Z-88
(2015)

Proposed Subdivision Layout
Blackwell Preserve Unit Two
Lots 307, 308, 341 & 342
16th District 2nd Section
Cobb County Georgia
Field Book Aug. 9, 2015
Plat & Master Aug. 6, 2015
Scale: 1"=300'

PETITION NO: Z-88

ZONING COMMENTS:

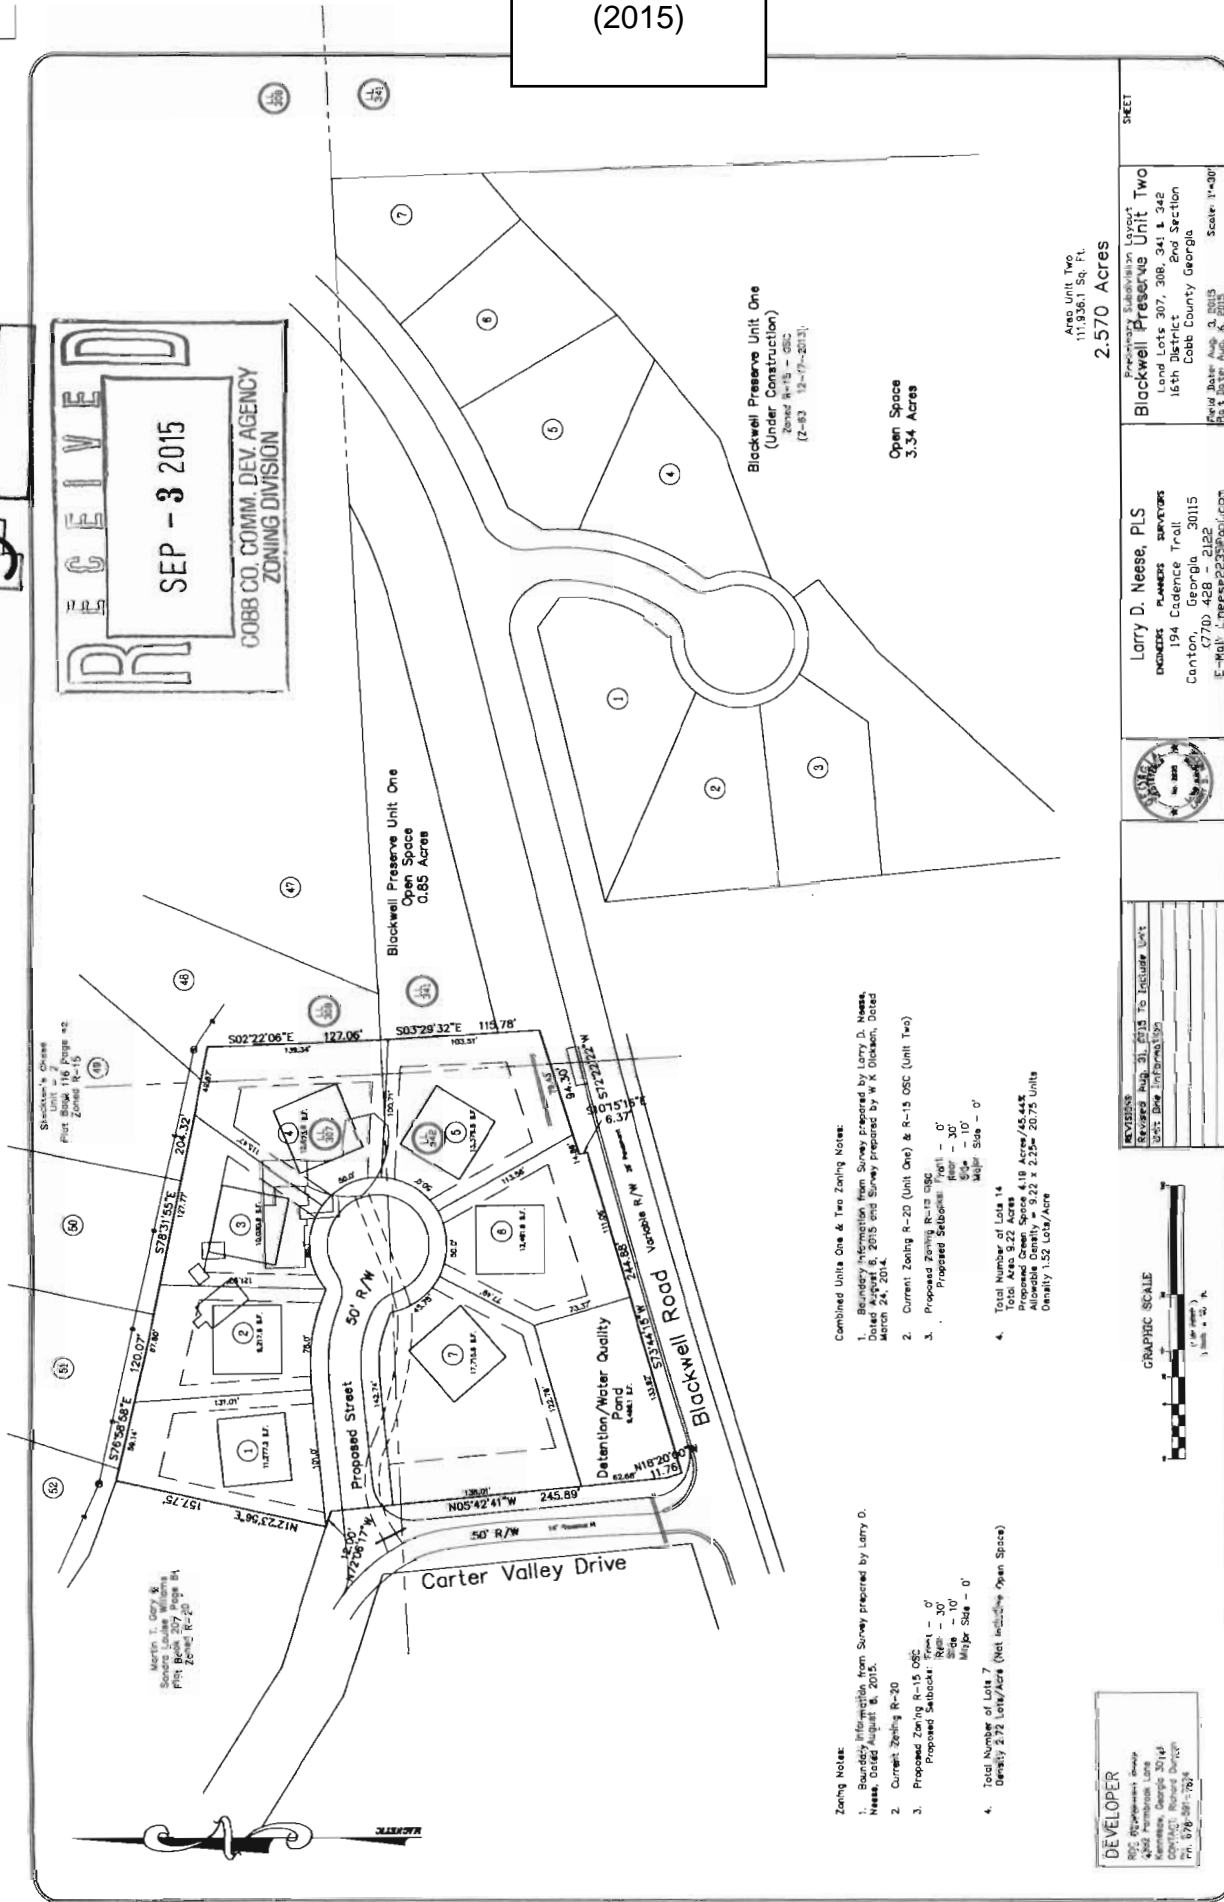
1. Need to make note on site plan whether or not Floodplain/wetlands/Lakes are present on both tracts of land that includes Unit 1 and Unit 2.
2. Contiguity of open space is highly desirable.

3. To conserve scenic views and reduce perceived density the proposal should maximize the number of houses with direct access to and views of open space.

4. One of the purposes and intent of the OSC is to promote interconnected greenways and corridors throughout the community; to promote greenspace as passive recreation. Consider designing a plan that connects open space and provides passive recreation opportunities.

5. Need to provide either a 25 foot dedicated open space strip or a 15 foot pedestrian easement to access contiguous open space.
6. Please list lot sizes for adjacent compatibility purposes.

7. For all lots setbacks should meet or exceed that of the underlying zoning.
8. Must have Cobb Department of Transportation approved lighting plan in if outdoor lighting (except individual residential lots) is proposed

- No Stormwater controls shown _____
- Copy of survey is not current – Additional comments may be forthcoming when current site conditions are exposed.
- No site improvements showing on exhibit.

1. The entire site drains to the west through the Rock Garden Subdivision into the floodplain of Rubes Creek via a small private farm pond within the Rock Garden Subdivision. A hydrologic routing will be required to verify no adverse impact to this pond. A pre- and post- sediment survey will also be required.
2. A 20-foot drainage easement and adequate pipe capacity must be provided at the rear of lots 5 and 6 to convey offsite runoff through the site.
